# Service Bulletin

Bulletin No.: 17-NA-246

**Subject:** Outer Window Belt Moldings Poor Fit and Retention

4890852

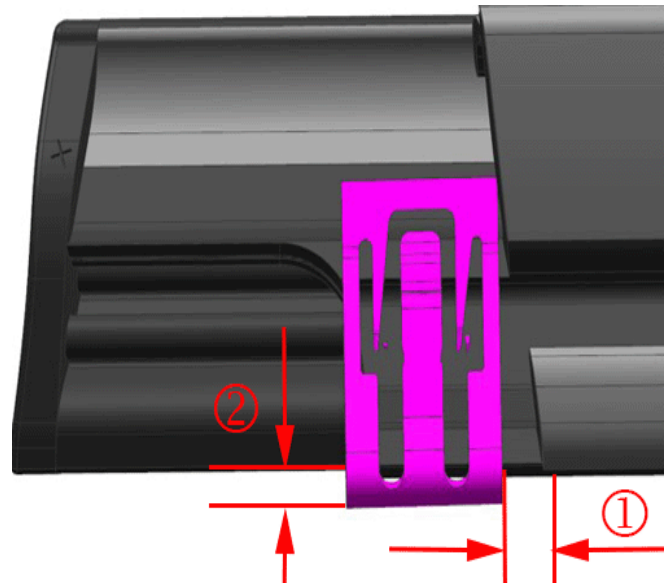
2. Install a clip at the B-pillar fore/aft from the corner of the trim per the picture.
3. Slide the clip onto belt molding stopping 2.0 mm (1) from the base of the molding per the picture. Be careful not to over install.
4. Re install the belt molding by aligning the belt molding end cap to edge of door. Making sure the belt molding clip is under the applique and the part is fully seated. You should hear audible click(s) when clip snaps under the applique.
5. Check installation retention by gently lifting part with finger tips. You should not be able to lift the belt molding with light pressure.

4890849

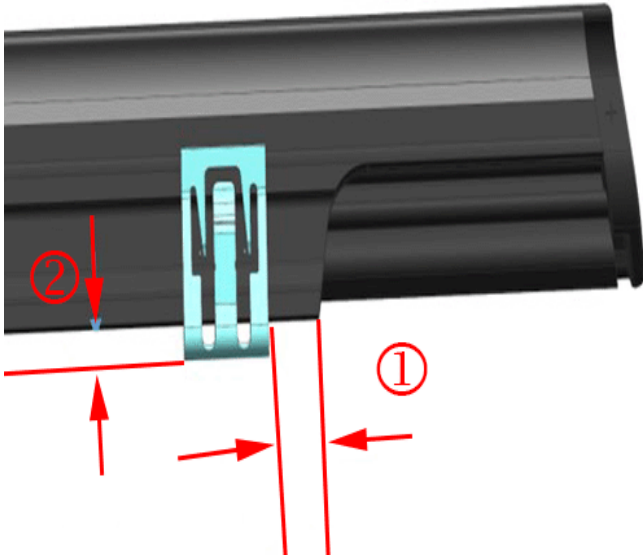
3. Install the clip at the C-pillar fore/aft 3.0 mm (1) from the trim per the picture.
4. Slide a clip onto belt molding stopping 2.0 mm (2) from the base of the molding per the picture. Be careful not to over install.
